Office Action Summary

10/537,155

DETAILED ACTION

Appendix A

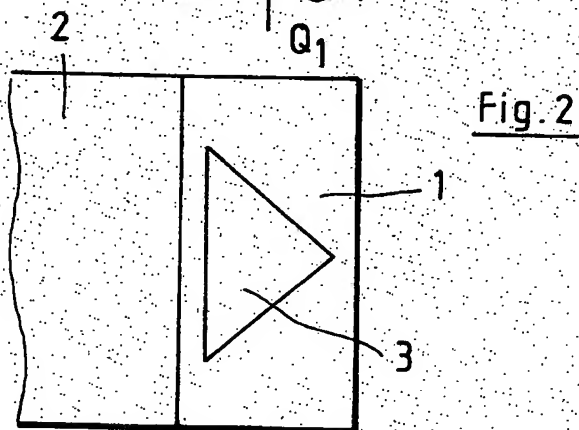
10. Specifically, in regard to amended claim 1, which is directed to a flow spreading mechanism, Ruscheweyh '786 discloses at least one inlet (inlet to feed conduit 2) through which a fluid flow (individual stream Q_2) is introduced; a flow separating means (delta-shaped insert element 3) for separating the fluid flow introduced through the at least one inlet into at least two fluid flows (separate streams between the edges of the delta-shaped insert element 3 and the conduit walls); and an outlet (A1, as annotated in attached Appendix A) for discharging at least two of the at least two fluid flows to an outside of the flow spreading mechanism (A3, dashed outline in Appendix A), at least two fluid flows being divided by the flow separating means (3) and joined together at a joining point (A2, as indicated in Appendix A) thereafter, wherein the outlet (A1) is located adjacent to the joining point (A2) where the at least two fluid flows are joined together such that the fluid flow being discharged through the outlet (A1) swings while proceeding due to complex vortices caused by the at least two fluid flows being joined together at the joining point (A2). See Ruscheweyh '786, Figure 1; column 1, lines 24-38; column 4, lines 65-68; and column 5, lines 1-8; also see attached Appendix A (annotated version of Figure 1 in Ruscheweyh '786). Therefore, because all of the elements in claim 1 of this application are disclosed by the Ruscheweyh '786 reference, this claim is rejected in accordance with 35 U.S.C. 102(b).

11. In regard to claim 2, which depends upon claim 1, Ruscheweyh '786 further discloses that the flow separating means comprises a plurality of conduits (main conduit 1 and feed

conduit 2) for providing the flow introduced from the inlet with flow paths. Refer to Ruscheweyh '786, Figure 1; column 4, lines 65-68; and column 5, lines 1-8. Thus, Ruscheweyh '786 meets the language of this claim.

12. In regard to claim 3, which depends upon claim 2, Ruscheweyh '786 further discloses that the number of the inlets is the same as that of the conduits (both main conduit 1 and feed conduit 2 have separate inlets), and each inlet corresponds to each conduit (the inlet through which stream Q_1 is introduced corresponds to main conduit 1, whereas the inlet through which stream Q_2 is introduced corresponds to feed conduit 2). See Ruscheweyh '786, Figure 1; column 4, lines 65-68; and column 5, lines 1-8. Consequently, the Ruscheweyh '786 reference also meets the language set forth in claim 3.

13. In regard to claim 4, which depends upon claim 2, Ruscheweyh '786 further discloses that the flow separating means comprises two conduits (main conduit 1 and feed conduit 2). Refer to Ruscheweyh '786, Figure 1; column 4, lines 65-68; and column 5, lines 1-8. Therefore, Ruscheweyh '786 also meets the language set forth in this claim.

Appendix B

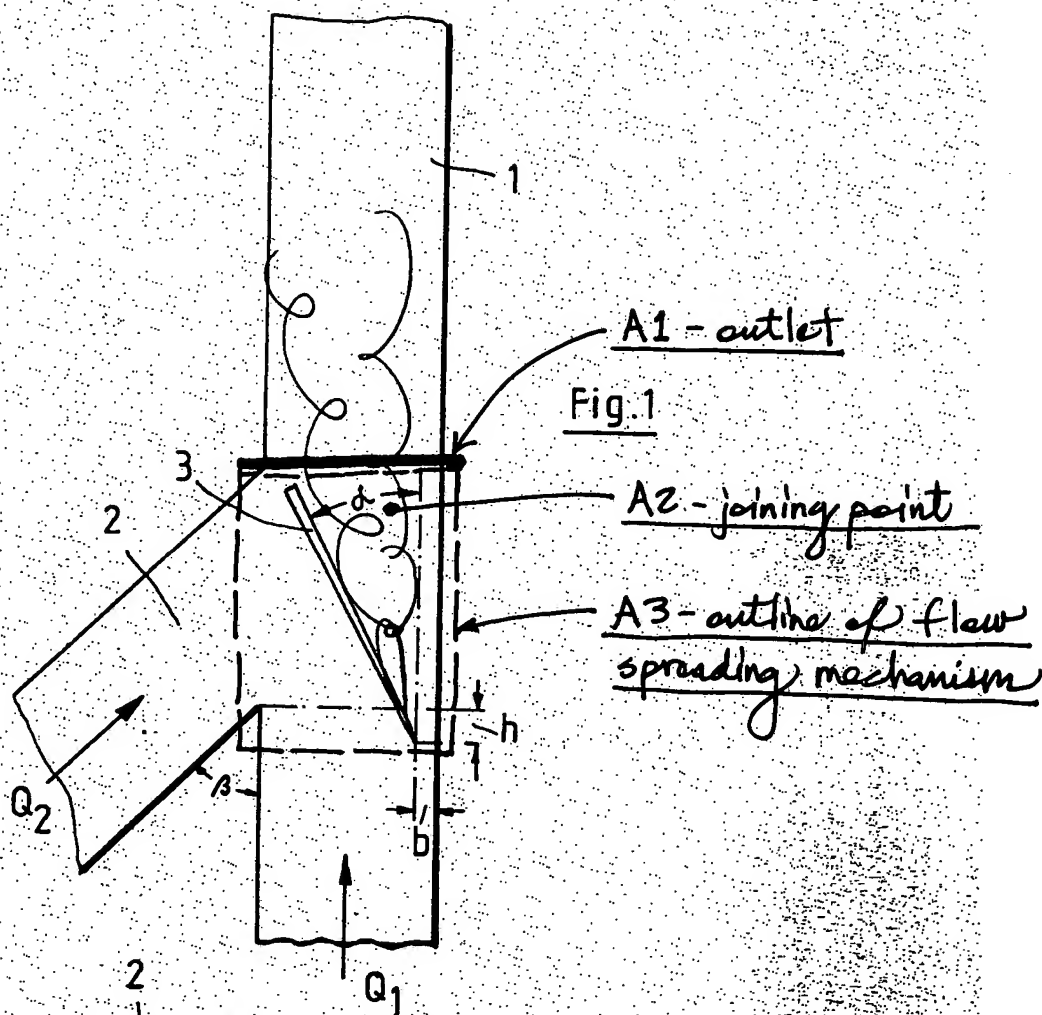
the edges of the ellipse or circular inclusion side 4 and the flow passage 2 walls); and an outlet (B1 at the beginning of outflow passage 3, as annotated in attached Appendix B) for discharging at least two of the at least two fluid flows to an outside of the flow spreading mechanism (B3, dashed outline in Appendix B), at least two fluid flows being divided by the flow separating means (4) and joined together at a joining point (B2, as indicated in Appendix B) thereafter, wherein the outlet (B1) is located adjacent to the joining point (B2) where the at least two fluid flows are joined together such that the fluid flow being discharged through the outlet (B1) swings while proceeding due to complex vortices caused by the at least two fluid flows being joined together at the joining point (B2). See Ruscheweyh '108, Figure 1; column 2, lines 41-50; column 3, lines 1-13; see also attached English translation of Ruscheweyh '108, paragraphs [0012-0014] and attached Appendix B (annotated version of Figure 1 in Ruscheweyh '108). Therefore, because all of the elements in claim 1 of this application are disclosed by the Ruscheweyh '108 reference, this claim is rejected in accordance with 35 U.S.C. 102(b).

20. In regard to new independent claim 22, Ruscheweyh '108 discloses all of the claimed elements, including: a conduit (2) having an inlet (inflow passage 1) and an outlet (B1 at the beginning of outflow passage 3, as annotated in attached Appendix B); and a blunt body (ellipse or circular inclusion side 4) placed inside the conduit (2) and configured to break an inlet fluid flow coming from the inlet (inflow passage 1) into at least two separate fluid flows (two streams

between the edges of the ellipse or circular inclusion side 4 and the flow passage 2 walls) and then join the at least two separate fluid flows at a joining point (B2, as indicated in Appendix B) thereafter into a discharge fluid flow discharged through the outlet (B1), wherein the outlet (B1) of the conduit (2) is located adjacent to the joining point (B2) where the at least two fluid flows are joined together such that the discharged fluid flow being discharged through the outlet (B1) swings while proceeding due to complex vortices caused by the at least two fluid flows being joined together at the joining point. See Ruscheweyh '108, Figure 1; column 2, lines 41-50; column 3, lines 1-13; see also attached English translation of Ruscheweyh '108, paragraphs [0012-0014] and attached Appendix B (annotated version of Figure 1 in Ruscheweyh '108). Therefore, because all of the elements in claim 22 of this application are disclosed by the Ruscheweyh '108 reference, this claim is rejected in accordance with 35 U.S.C. 102(b).

22. In regard to claim 26, which depends upon claim 23, Ruscheweyh '108 further discloses that distance (dimension B4 in Appendix B) between the blunt body (4) and the outlet (B1) is smaller than a width of the outlet (B1). See attached Appendix B (annotated version of Figure 1 in Ruscheweyh '108). Consequently, the Ruscheweyh '108 reference also meets the language set forth in claim 26.

Appendix C

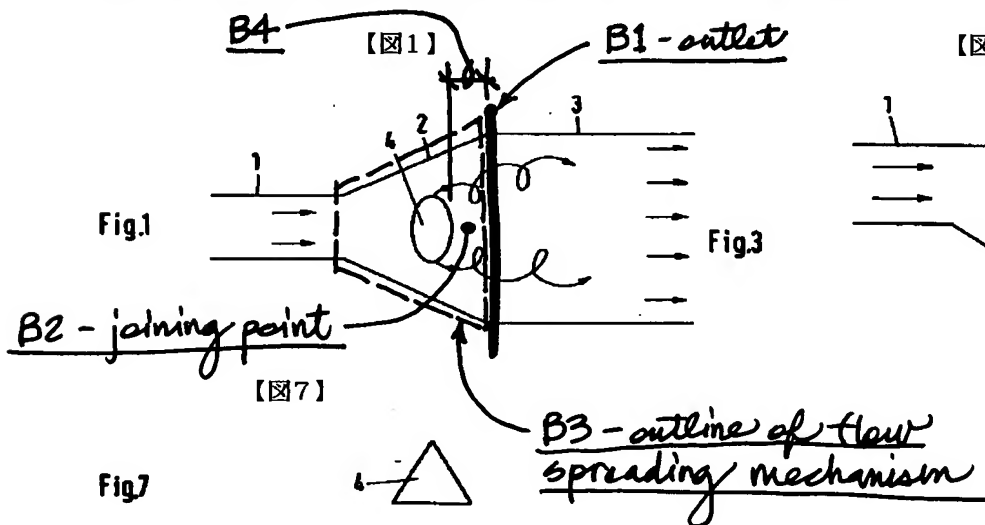
27. In particular, claims 10 and 24 of this application are obvious when Ruscheweyh '108 is viewed in light of the embodiment depicted in Figure 15 of Ruscheweyh '786. As described above, Ruscheweyh '108 discloses all the limitations of claims 6 and 22, the two claims upon which these claims respectively depend. However, claims 10 and 24 further disclose that the ends of the conduit on the side of the outlet are symmetrically bent toward the centerline. Ruscheweyh '108 does not contain this additional limitation. Although, the embodiment depicted in Figure 15 of Ruscheweyh '786 teaches that the ends of the conduit (main conduit 1) on the side of the outlet (outlet conduit 1a) are symmetrically bent toward the center of the conduit so that the width of the outlet (outlet conduit 1a) is smaller than the width of the conduit (main conduit 1). Refer to Ruscheweyh '786, Figure 15 and column 7, lines 58-60. Ruscheweyh '786 is analogous prior art under 35 U.S.C. 103 because the fluid spreading mechanism disclosed

in this application and the fluid mixing apparatus in Ruscheweyh '786 are from the same field of endeavor, namely devices capable of mixing and spreading fluid streams. See Ruscheweyh '786, column 1, lines 24-38. Moreover, there is sufficient motivation to combine the embodiment depicted in Figure 15 of Ruscheweyh '786 with Ruscheweyh '108 because the embodiment depicted in Figure 15 of Ruscheweyh '786 teaches a main conduit with convergent walls for the purpose of forming a constricted outlet with a higher resultant discharge velocity. Refer to Ruscheweyh '786, column 4, lines 48-49 and column 7, lines 58-60. Therefore, when Ruscheweyh '108 is viewed in light of the embodiment depicted in Figure 15 of Ruscheweyh '786, it would have been obvious to one having ordinary skill in the art at the time the invention was made to provide the flow spreading mechanism disclosed by Ruscheweyh '108 with symmetrical, convergent walls immediately upstream of the outlet, as taught by the embodiment depicted in Figure 15 of Ruscheweyh '786, in order to form a constricted outlet with a fluid velocity higher than the velocity upstream of the flow separating means. See Ruscheweyh '786, column 4, lines 48-49 and column 7, lines 58-60.

Ruscheweyh '786 teaches that the ends of the conduit (main conduit 1) on the side of the outlet (outlet conduit 1a) are symmetrically bent toward the center of the conduit so that the width of the outlet (outlet conduit 1a) is smaller than the width of the conduit (main conduit 1) for the purpose of forming a constricted outlet with a higher resultant discharge velocity. Refer to Ruscheweyh '786, Figure 15; column 4, lines 48-49; and column 7, lines 58-60. Moreover, the embodiment depicted in Figure 7 of Ruscheweyh '786 teaches that an interval between the plate and the outlet (space between the top edge of delta-shaped insert element 3 and the point at which feed conduit 2b meets main conduit 1 – dimension C4 in Appendix C) that is set smaller than the width of the outlet (width of main conduit 1 – dimension C5 in Appendix C) such that the flow path from the both sides of the plate to the outlet functions as nozzles (a diverging nozzle is formed between the delta-shaped insert element 3 and the upper wall of the feed conduit 2b, while, on the opposite side of the element 3, a converging nozzle is formed between the element and the lower wall of the feed conduit 2b) for the purpose of increasing the discharge velocity of fluid stream and facilitating spreading and mixing. See Ruscheweyh '786, Figure 7; see also attached Appendix C (annotated version of Figure 7 in Ruscheweyh '786). Therefore, it would have been obvious to one having ordinary skill in the art at the time the invention was made to provide the flow spreading mechanism of Ruscheweyh '786, with symmetrically bent ends on the side of the outlet, as taught by the embodiment depicted in Figure 15 of Ruscheweyh '786, and with an interval between the blunt body and the outlet that is set smaller than the width of the outlet, as taught by the embodiment depicted in Figure 7 of Ruscheweyh '786, in order to form a constricted outlet with a higher resultant fluid discharge velocity so that the spreading and mixing of the discharged fluid is facilitated. Refer to Ruscheweyh '786, column 6, lines 30-35.
